Finding Of No Significant Impact

Potomac Park Levee System Improvements

National Mall and Memorial Parks and the National Capital Region

Abstract Diagram of Existing Rights of Way, Centerlines, and "Extensions" Thereof
Bearing on Lindsley Williams' Comments on the Proposed 17th Street Levee and its EA

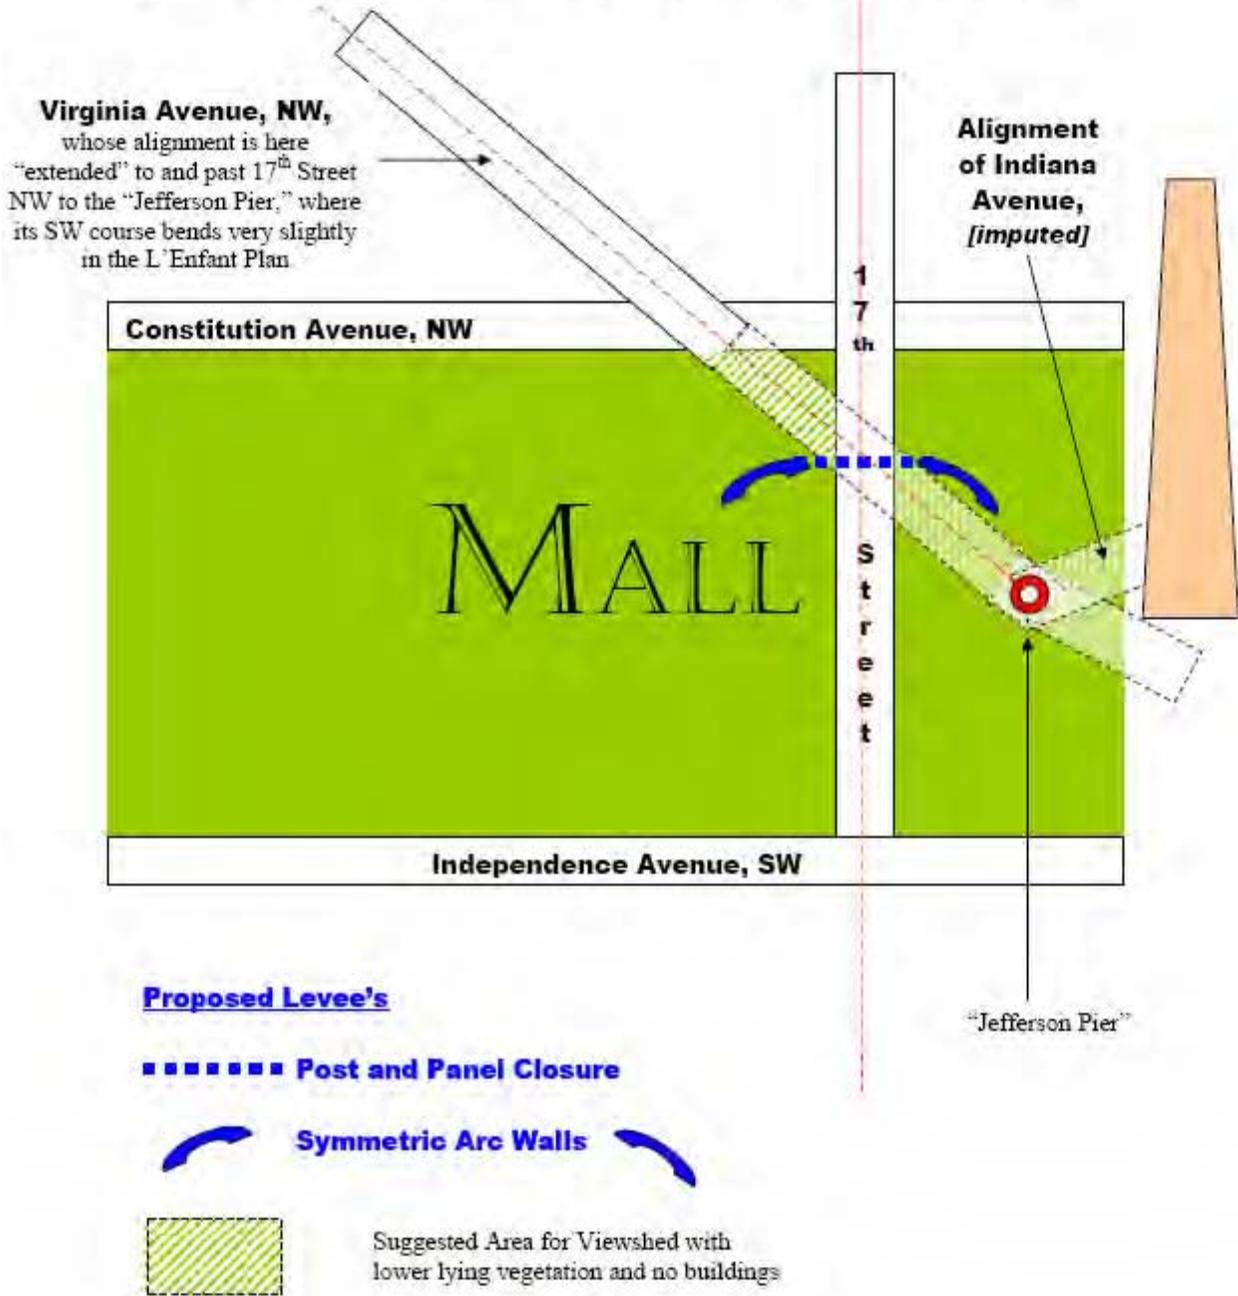
Option 1B proposes a design that is symmetric, centered on the centerline of 17th Street, NW whose right of way *north* of Constitution is part of the historic L'Enfant Plan. My own studies suggest that this alignment continues to the south, but the mid-point of the symmetry should be the axis of 17th Street in the L'Enfant Plan, even if this is not quite the same as that of 17th Street south of Constitution.

Surviving **open** portions of these rights of way, particularly that of Virginia Avenue, NW, constitute critical view corridors that are urban assets to be preserved and enhanced. In the context of this project and this particular EA, I urge you to build on the EA's own extensive analysis of "viewsheds" that aimed to reduce losses from the development of any levee alternative. As the EA notes (at page 2-43), of all the "remaining diagonal vistas" that L'Enfant's plan provided, Virginia Avenue northwest of the site of the levee closure is the only one that survives at this time relevant to this project. I recommend that asset be examined carefully so that the **north-south** placement of the post-and-panel wall and the two symmetric flanking arc walls be centered not only on the axis of 17th Street but also on the axis of Virginia Avenue as it was laid out by L'Enfant to the northwest, the latter axis terminating at the "Jefferson Pier" southwest of the site and due west of the Washington Monument.

opening. The viewshed is maximized as the width of post and panels increases and as the height of the arc walls is reduced. Indeed, if segments of the permanent wall closest to the gap that the post and panels close in flood events could be reduced in their height, with additional panels or other barriers added to bring needed protection in flood events, that would also reduce the adverse impact the built walls would have.

I ask, however, that you confirm my math, correct it if need be, and, in particular, place suitable “monuments” along the two arc walls **above** their cap showing where the overall right of way of Virginia Avenue would have passed had that Avenue ever been developed across the Mall. While I am not recommending any such development, as an active roadway, I strongly recommend that the Park Service declare, as part of their Plan for the National Mall, the area within the overall Virginia Avenue’s hypothetical alignment as a “no build” area for any **building** use other than those needed by the Levee, that the area be one that would be landscaped with surface and low lying plants so as to open up vistas of the Monument from the northwest along the resulting viewshed. Doing so would support the EA’s own discussion of the value of viewsheds and vistas and, further, promote the urban design and cultural objectives being articulated by the National Capital Planning Commission in its soon-to-be released “**Framework Plan**” as they relate to significant viewsheds in the Nation’s capital – one of which they identify as being that along Virginia Avenue NW.

4	Lindsley Williams	From my examination of historic records, I know that the Virginia Avenue right of way northwest of Constitution Avenue is 120 feet. I have also collected and extrapolated data on the east-west and north-south distance this right of way utilizes. From my math (which used lengths stated of	See final response to comment #1/2.
